**TOWN OF MOUNTAIN VILLAGE
REGULAR DESIGN REVIEW BOARD MEETING
AGENDA**

THURSDAY DECEMBER 3, 2020 10:00 AM

4.	10:10	60	Ward Applicant	Quasi-Judicial	Consideration of a Design Review: Initial Architecture Review for a new single-family residence on Lots 517 & 518 (518R) 146 Russell Drive, pursuant to CDC Section 17.4.11

LANDSCAPE PLAN

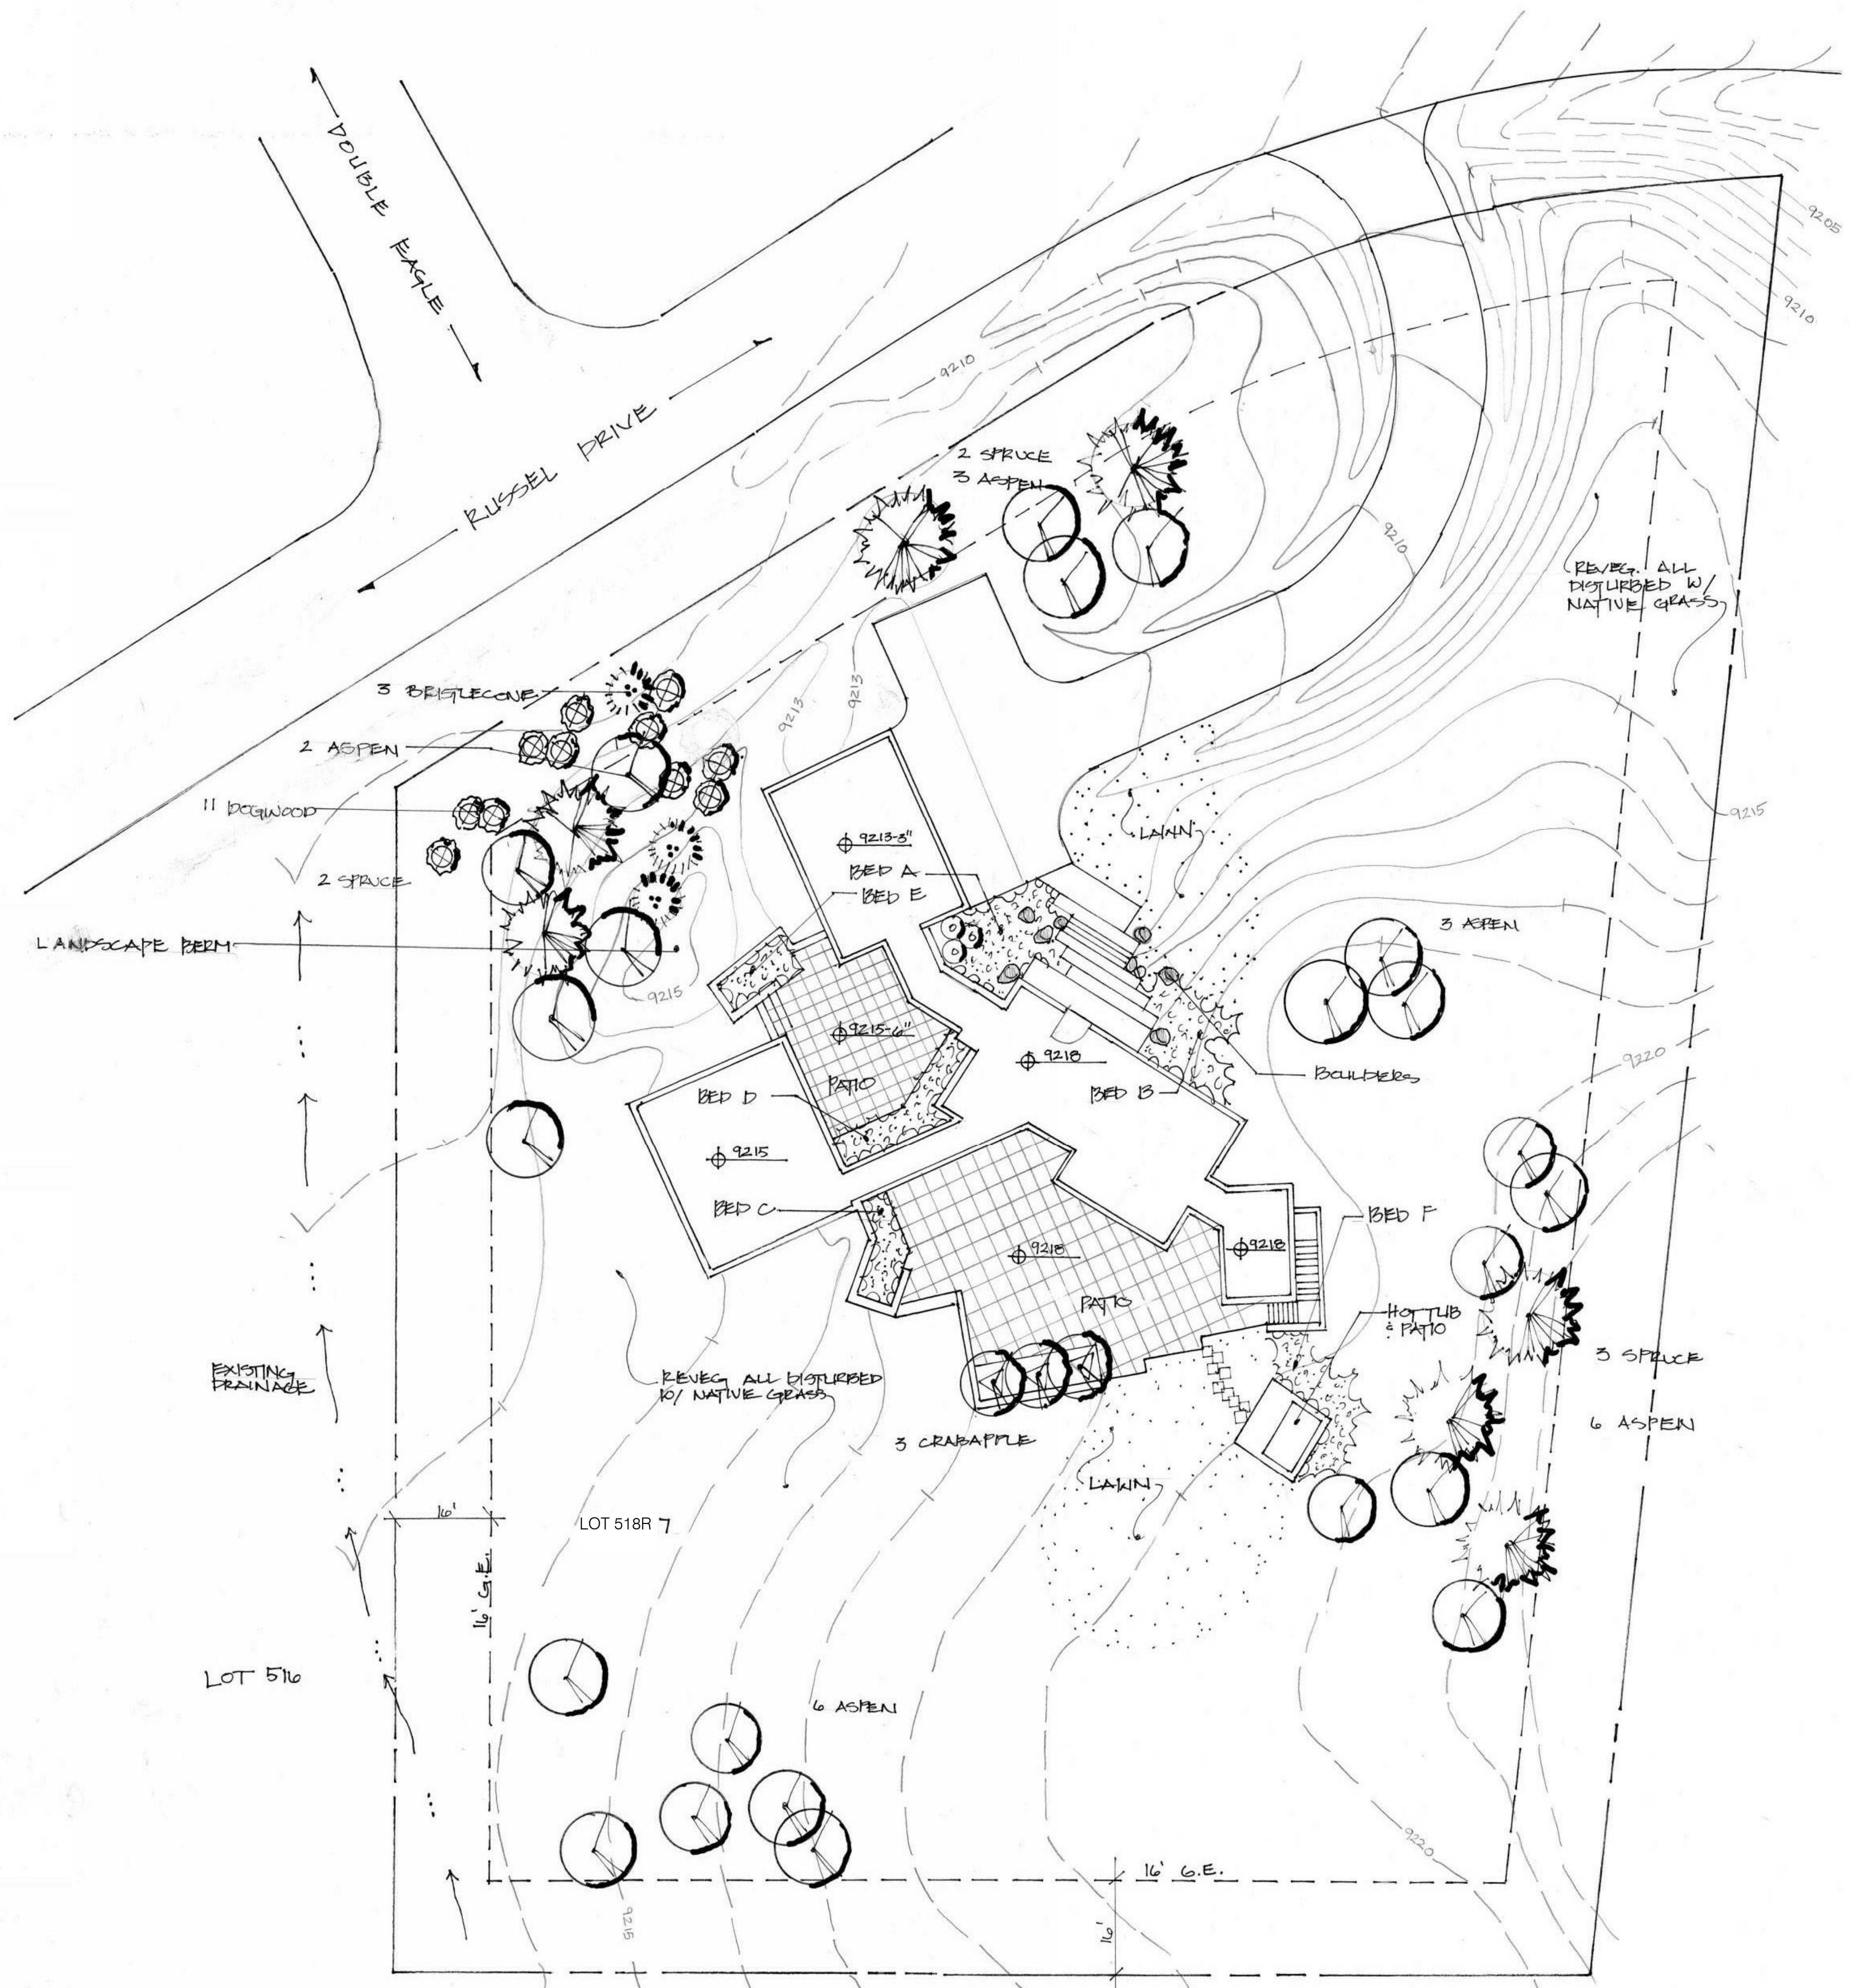
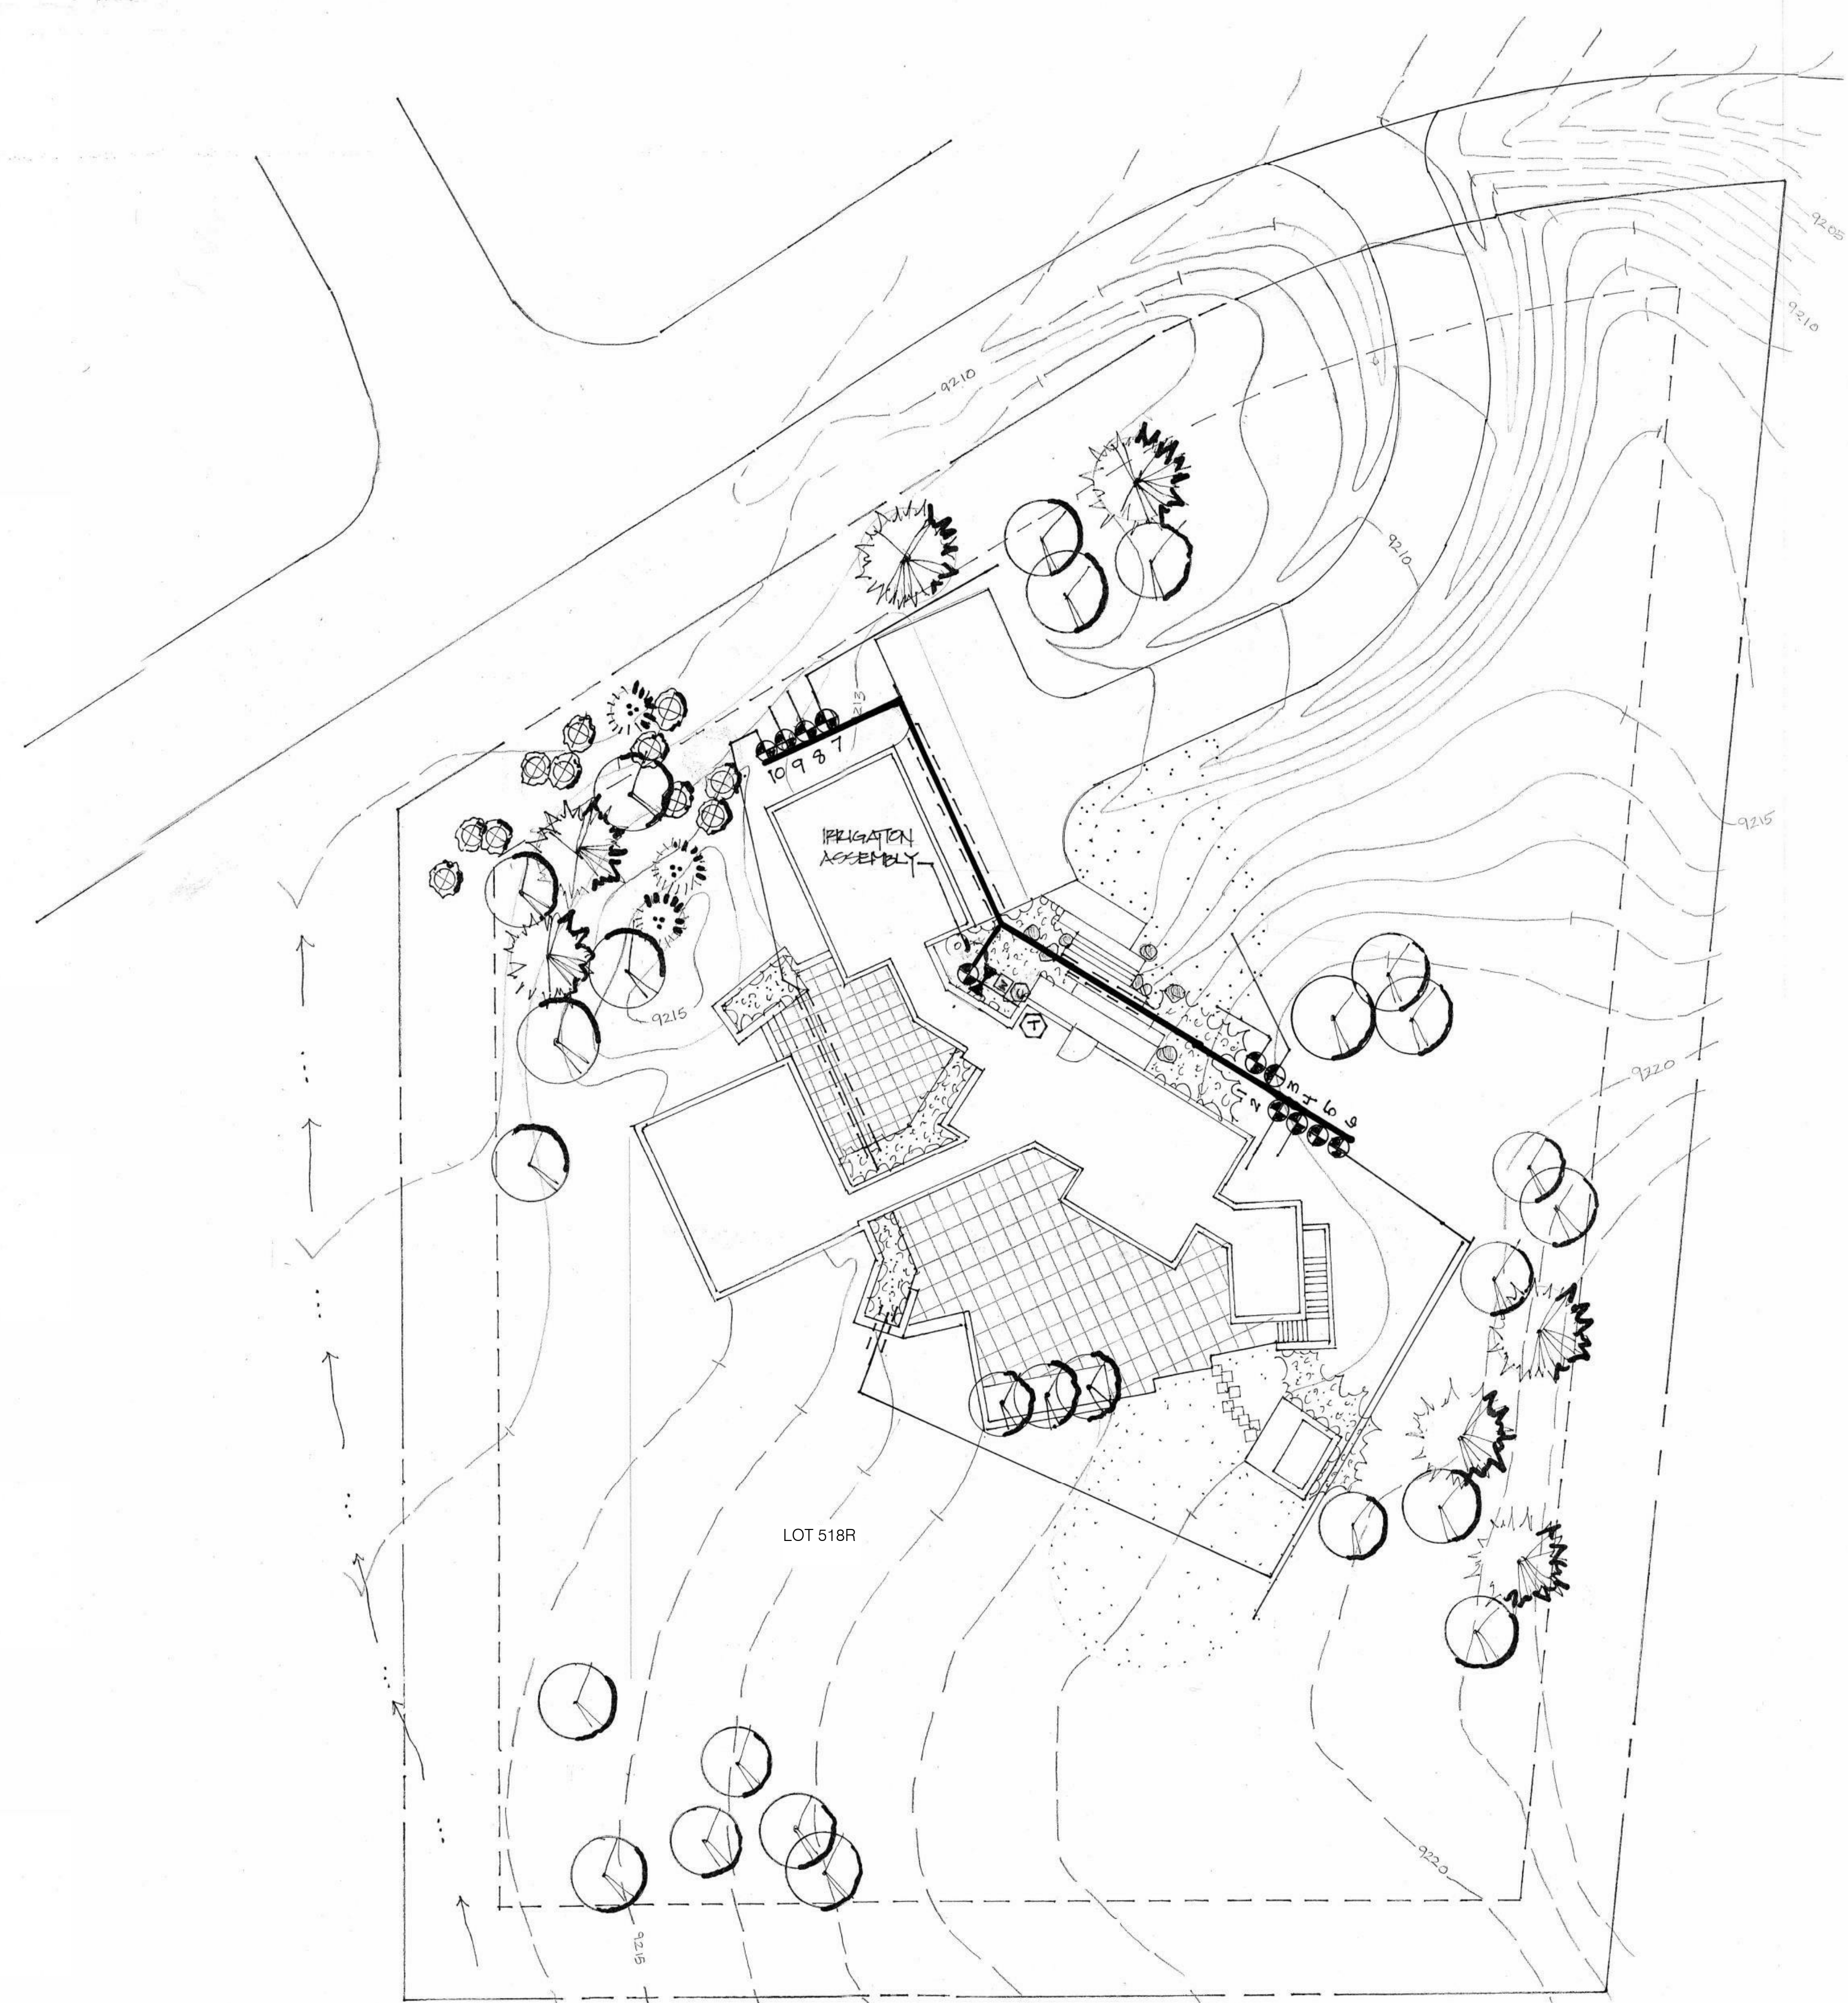
The applicant has provided a landscaping plan to include irrigation notes, revegetation notes, and other general requirements. Prior to final, the applicant shall submit a fire mitigation plan that meets the Forestry provisions of the CDC revising the plan so that all plantings within Zone 1 are listed in the approved planting list within the CDC..

Staff: Fire Mitigation and Forestry Management: A more detailed plan, indicating zones needs to be provide for FAR.

- 1) Prior to the submittal for a Final Architectural Review, the applicant shall provide a fire mitigation plan, showing that there are no prohibited combustibles in Zone 1 per the forestry provisions of the CDC.
